# UNITED STATES PATENT AND TRADEMARK OFFICE

APPLICATION NO.	FILING DATE	FIRST NAMED INVENTOR	ATTORNEY DOCKET NO.	CONFIRMATION NO.
10/814,348	04/01/2004	Serge Bisson	44117-138	5328
20277	7590	06/13/2006	EXAMINER	
MCDERMOTT WILL & EMERY LLP			GABLER, PHILIP FRANCIS	
600 13TH STREET, N.W.			ART UNIT	
WASHINGTON, DC 20005-3096			PAPER NUMBER	
			3637

<b>Office Action Summary</b>	Application No.	Applicant(s)	
	10/814,348	BISSON ET AL.	
	Examiner	Art Unit	
	Philip Gabler	3637

## **DETAILED ACTION**

Exhibit 1: Bitel '773 Figures 1 and 3

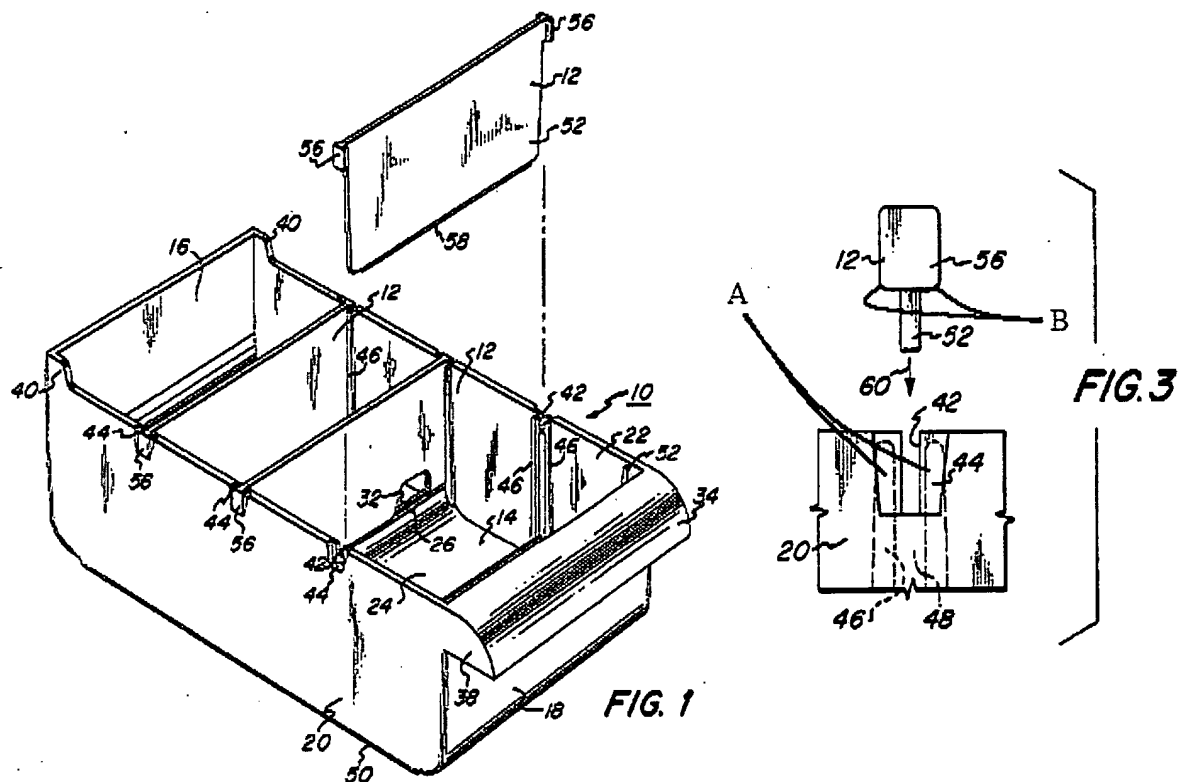
10. Regarding claims 1 and 13, Bitel (Figures 1 and 3) discloses a partitioning/fastening arrangement for a partitioning wall in a drawer comprising: a partitioning wall (12) having a pair of elongated blades (56) in the partitioning wall [Note that the limitation “punched” is a product by process limitation. The product itself does not depend on the process of making it. The limitation “punched” would not be expected to impart distinctive structural characteristics to the device.] and projecting sideways from the partitioning wall adjacent ends thereof at a predetermined height of the partition wall, each blade extending vertically along a corresponding adjacent end of the partitioning wall and comprising a lower ramp surface (viewed as angles B) defined

by the partitioning wall and said predetermined height; and opposite connecting elements (42, 44, and surrounding area) respectively projecting from the support walls at heights matching with the height of the blades of the partitioning wall when the partitioning wall is in operative position between the support walls (20, 22), the connecting elements having retaining channels (42, 44) in which the ends of the partitioning wall are uprightly slideably engageable, the retaining channels having opposite side locking lips (viewed as A in Exhibit 1) forming guiding slots for passage of a section of the partitioning wall extending between the connecting elements, the ramp surfaces of the blades of the partitioning wall being shaped and sized for facilitating insertion of the blades in the retaining channels and for respectively and progressively press-fitting against inner sides of said channels behind the locking lips when the partitioning wall is in the operative position (the press-fit would be progressive based on the shape of 44 of the retaining channel).

11. Regarding claims 2 and 14, Bitel further discloses opposite support elements (46) respectively projecting from the support walls at another height with respect to the connecting elements, the support elements respectively having guiding slots (48) in which the ends of the partitioning wall are slideably engageable, the guiding slots of the support elements being aligned with the guiding slots of the retaining channels of the connecting elements (see Figure 3).

12. Regarding claims 5 and 16, Bitel further discloses the support elements extend below the connecting elements (see Figure 1).

13. Regarding claims 7 and 18, Bitel further discloses the blades extend directly at the ends of the partitioning wall.

14. Regarding claims 8 and 19, Bitel further discloses a seating flange (58) projecting from a bottom end of the partitioning wall and extending laterally with respect thereto.

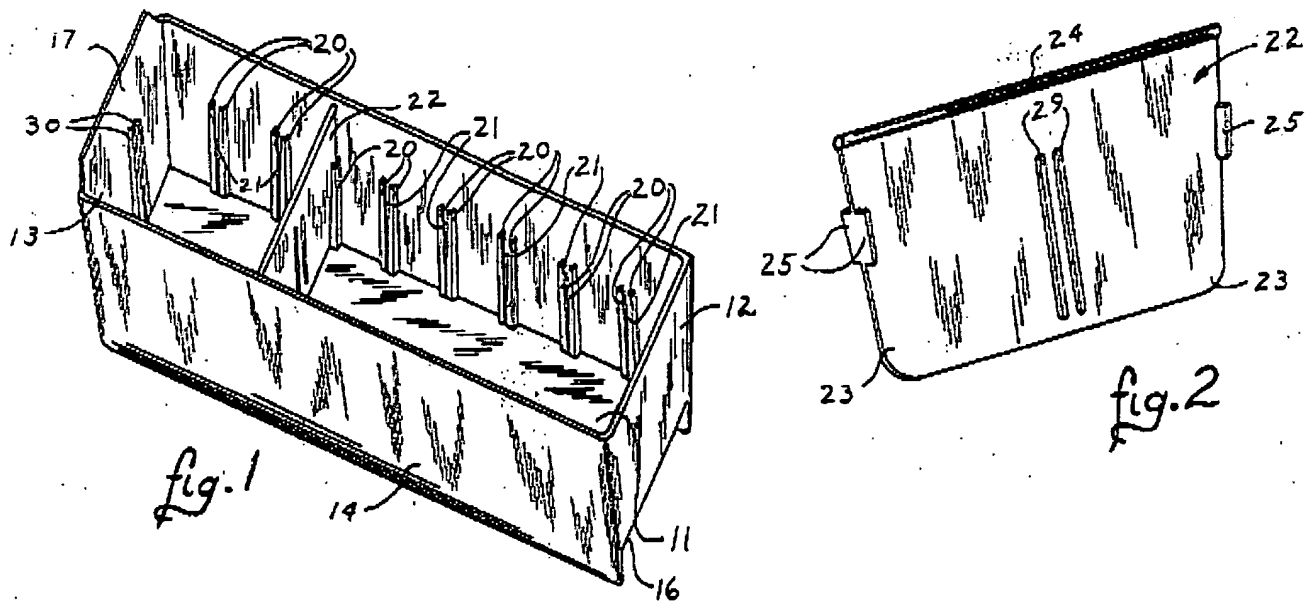
17. Regarding claims 1 and 13, Hollenstein (Figures 1 and 2) discloses a drawer partition system comprising a partitioning wall (4); and opposite connecting elements (23, 27) respectively projecting from support walls (32, note that while only one support wall is shown, it is inherent that more would be present in a drawer arrangement) at heights matching with the height of a partitioning wall (4) when the partitioning wall is in operative position between support walls, the connecting elements having retaining channels (27) in which the ends of the partitioning wall are uprightly slideably engageable, the retaining channels having opposite side locking lips (viewed as B in Exhibit 2) forming guiding slots for passage of a section of the partitioning wall extending between the connecting elements. Hollenstein does not disclose a pair of blades in the partitioning wall. Bitel discloses a partition arrangement for a drawer including elongated blades (56) in a partitioning wall and projecting sideways from the partitioning wall adjacent ends thereof at a predetermined height of the partition wall, each blade extending vertically along a corresponding adjacent end of the partitioning wall and comprising a lower ramp surface (viewed as angles B) defined by the

partitioning wall and said predetermined height, the blades fitting in channels (42, 44). Accordingly, it would have been obvious to one of ordinary skill in the art at the time the invention was made to modify Hollenstein's partitioning system to comprise elongated blades on both sides of the partitioning wall as taught by Bitel because this arrangement could allow for more control over the fit of the partitions.

18. Regarding claims 2 and 14, Hollenstein further discloses opposite support elements (21, 26) respectively projecting from the support walls at another height with respect to the connecting elements, the support elements respectively having guiding slots (26) in which the ends of the partitioning wall are slideably engageable, the guiding slots of the support elements being aligned with the guiding slots of the retaining channels of the connecting elements (see Figure 2).

19. Regarding claims 3 and 15, Hollenstein further discloses the connecting (23, 27) and support (21, 26) elements comprising longitudinal extrusions (21, 23) made in the support walls (32) and projecting on a side thereof, with retaining channels (27) and guiding slots (26) being made in and extending crosswise to the extrusions of respective ones of the connecting and support elements.

20. Regarding claim 4, Hollenstein further discloses the extrusions have substantially rounded upper and lower surfaces (viewed as curves A in Exhibit 2) for joining the support walls.

21. Regarding claim 9, Hollenstein further discloses an additional connecting element (24) projecting from at least one of the support walls at a height to receive a partitioning wall (4), the additional connecting element being like the connecting element

already made in said at least one of the support walls but projecting on a side of said at least one of the support walls opposite to a side on which the connecting element already made in said at least one of the support walls projects (see Figure 2).

22. Regarding claim 10, Hollenstein further discloses an additional connecting element (24) projecting from at least one of the support walls at a height to receive a partitioning wall (4), and an additional support element (22) projecting from said at least one of the support walls at another height with respect to the additional connecting element, the additional connecting and support elements being respectively like the connecting and support elements (21, 23, 26, 27) already made in said at least one of the support walls but projecting on a side of said at least one of the support walls opposite to a side on which the connecting and support elements already made in said at least one of the support walls project (see Figure 2).

Kleinert et al. '215 Figures 1 and 2

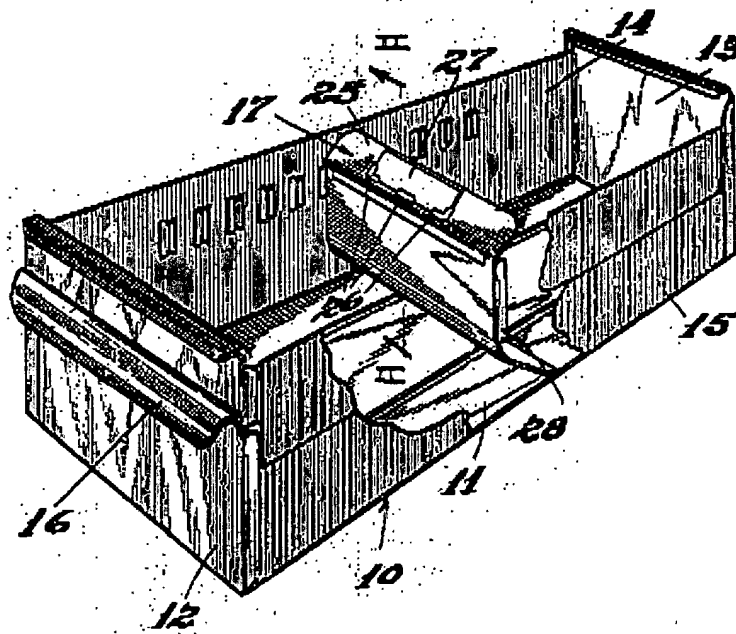
25. Claims 20-23 are rejected under 35 U.S.C. 103(a) as being unpatentable over Hollenstein in view Bitel and further in view of Kleinert et al. (US Patent Number 4436215). Hollenstein, when modified by Bitel as described above, discloses a partitioning system as recited in claim 14 as well as connecting and support elements as recited in claims 20-23, but does not disclose similar connecting and support elements on a partitioning wall in addition to the support walls. Kleinert (Figures 1 and 2) discloses a partition system for a drawer including a partitioning wall (22) comprising connecting/support elements (29) like the connecting/support elements (30) of his

support walls (13, etc.), the partitioning wall capable of forming a support wall for another partitioning wall. Accordingly, it would have been obvious to one of ordinary skill in the art at the time the invention was made to modify Hollenstein's partitioning wall, in his partitioning system previously modified by Bitel, to include connecting/support elements on his partitioning wall in addition to those on his support walls as taught by Kleinert because this would allow a more partitions to be added to the system and increase its versatility.
